**Response to Request for Information  
Oakdale West Estate – Proposed Industrial Facility Precinct 5 (DA22/0546)**

This letter has been prepared by *Keylan Consulting Pty Ltd* (Keylan) on behalf of *Goodman Property Services (Aust) Pty Ltd* (the Applicant) in response to Penrith City Council's (Council) letter dated 7 September 2022 in relation to the above development application (DA 22/0546).

Figure 2: Revised Site Plan (Source SBA, 10 November 2022)

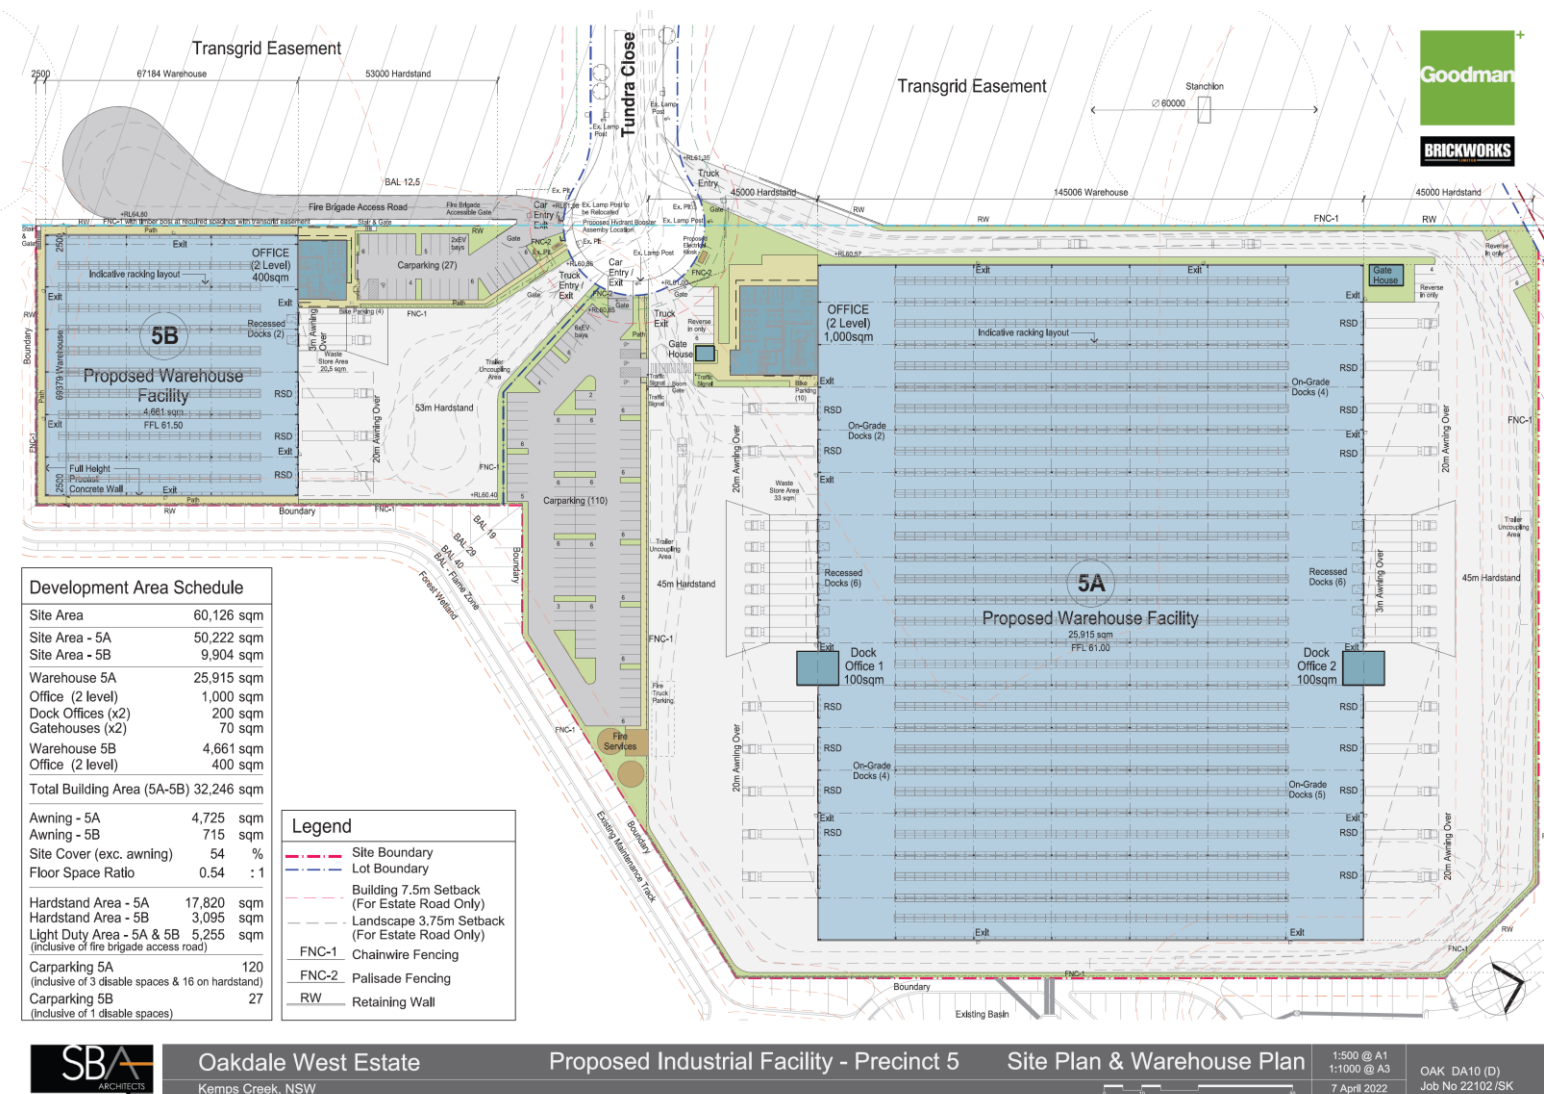
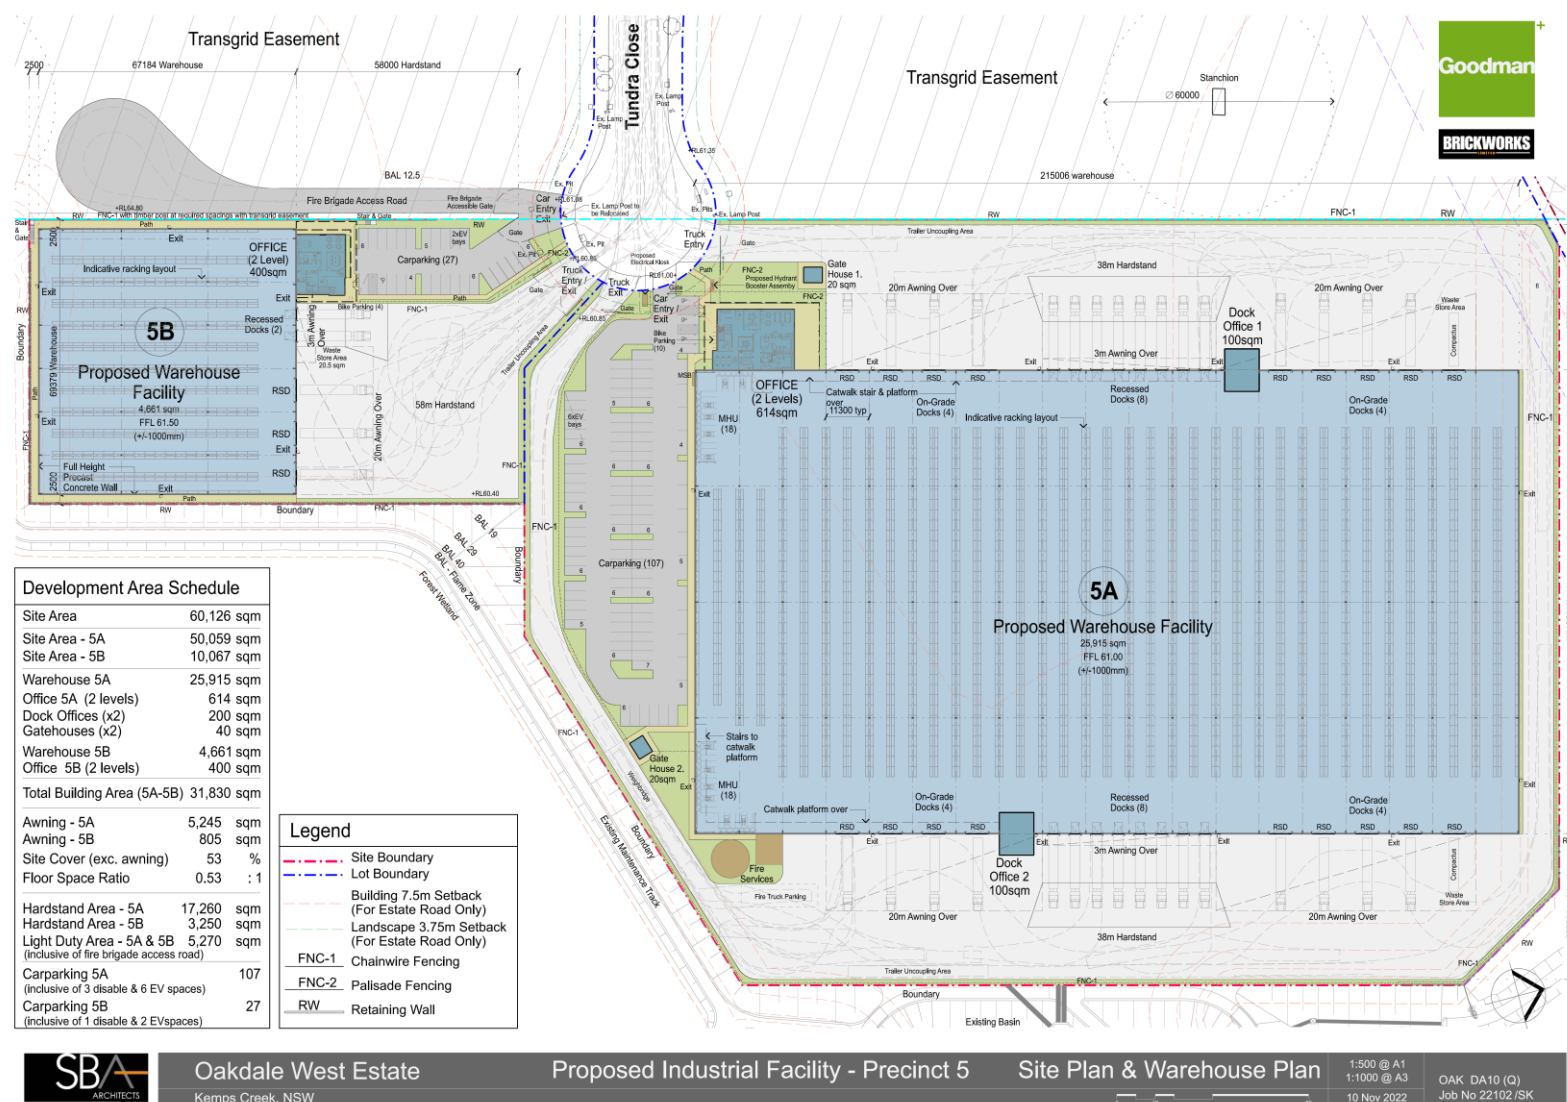
The key change is a 90-degree reorientation of Warehouse 5A to a north south orientation (previously east west) to address Council's concerns raised about the pedestrian access to the building across the truck exit and hardstand.

- reconfiguration of the driveways and crossovers at the cul-de-sac site access point
- relocation of the Warehouse 5A loading docks, dock offices and gatehouse
- parking provisions for Warehouse 5A have reduced to 106 car parking spaces (previously 120).
- reduction in the total building area (5A & 5B) from 32,246 m<sup>2</sup> to 31,830 m<sup>2</sup>
- slight reduction in the Floor Space Ratio from 0.54:1 to 0.53:1 in the Revised Site Plan
- hardstand areas for Warehouse 5A and 5B have been decreased from 20,915m<sup>2</sup> to 20,510m<sup>2</sup>

The changes are documented in the revised Site Layout Plan (Revised Site Plan), which is at Figure 2 below and within the updated Architectural Plans at Attachment C.
